**BID No. 2007 - NEW HIGHWAY FACILITY****COUNTY OF MADISON****EATON, NEW YORK****ADDENDUM #6****MARCH 18, 2020**

**New Highway Facility**

**Response to Inquiries – Addendum #6**

**C1 NORTH ELEVATION**  
SCALE: 1/8" = 1'-0"

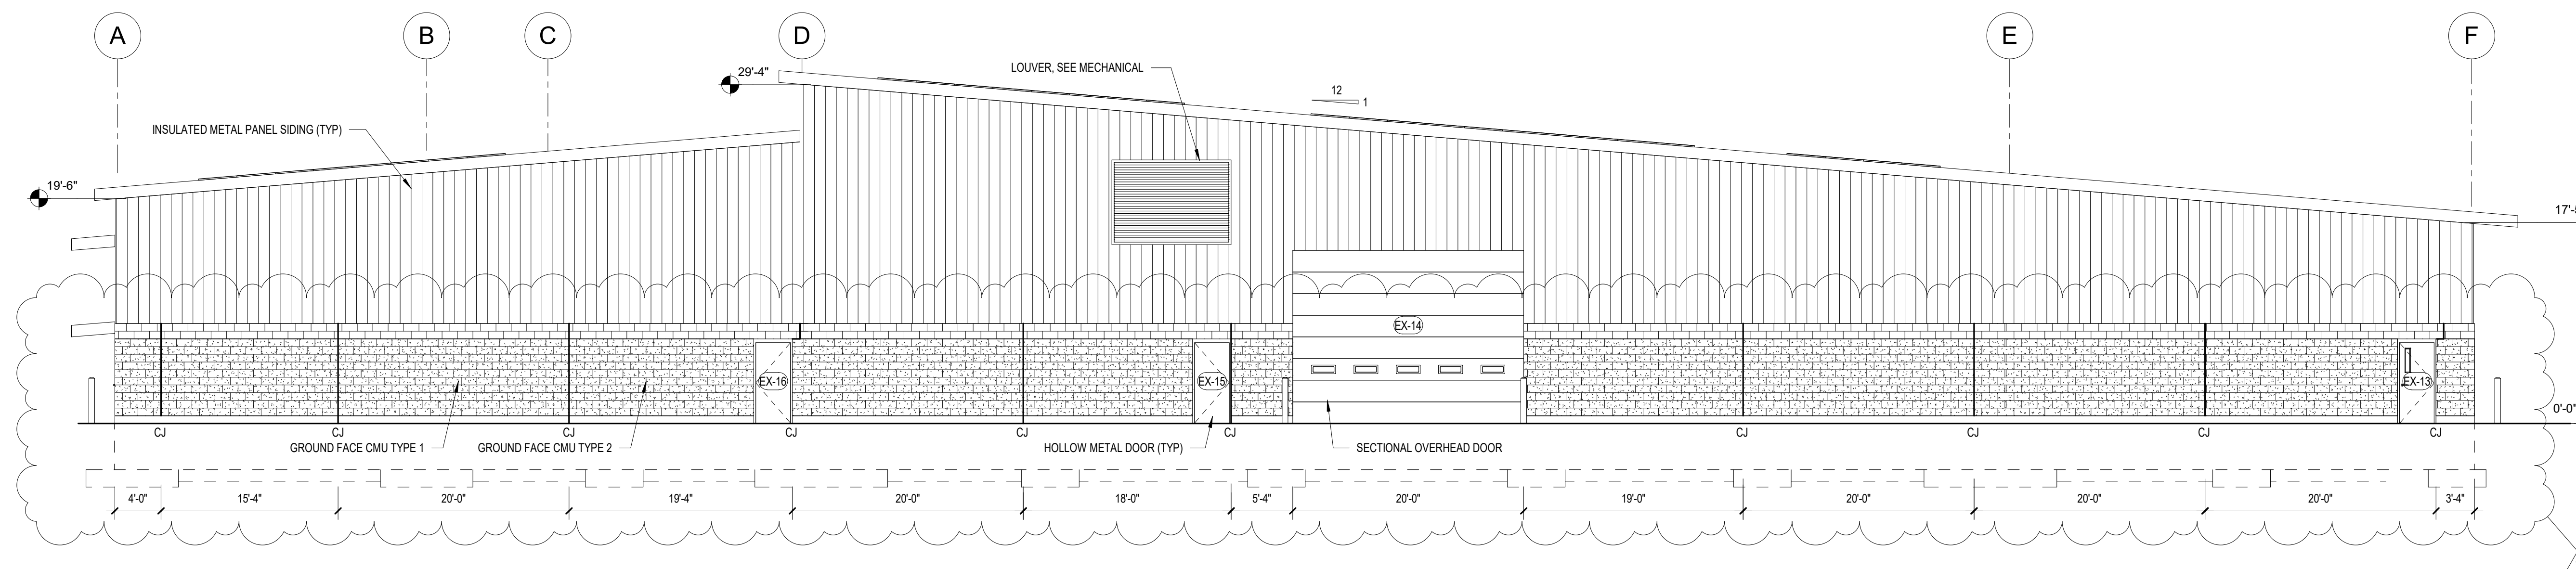
- 6. Drawing A-201, A-202, and A-203 – Exterior Elevations; **DELETE** drawings and **SUBSTITUTE THEREFOR** with attached Drawings A-201 Revision 1, A-202 Revision 1, and A-203 Revision 1 dated 3/18/2020. These elevations clarify the location and quantity of CMU control joints.
